# Access Compliance Report

## Public Rights-of-Way

| Intersection ID: 9325                   | Main Street: FREEDOM_DR | Cross Street: MARLENE_ST                | Location: S            |
| ADA ID: F024F1BDF2D3                    | Ramp Type: Perp         | Initial Pass/Fail: Fail                 | Overall Compliance: No |

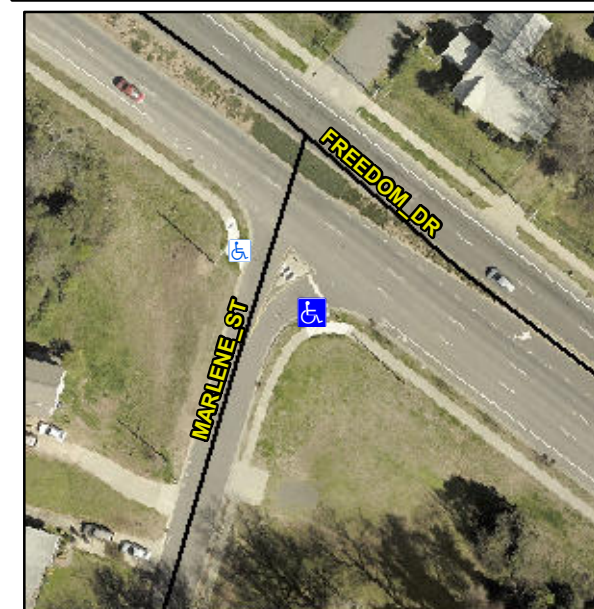
**Remove & Replace Entire Ramp.**

**Not Found, R304.5.1, R304.5.3**

| Compliance | Description           | Data  | Compliance | Description                 | Data |
|------------|-----------------------|-------|------------|-----------------------------|------|
| No         | Ramp Width (in)       | 47.5  | No         | Ramp XSlope (%)             | 8.0  |
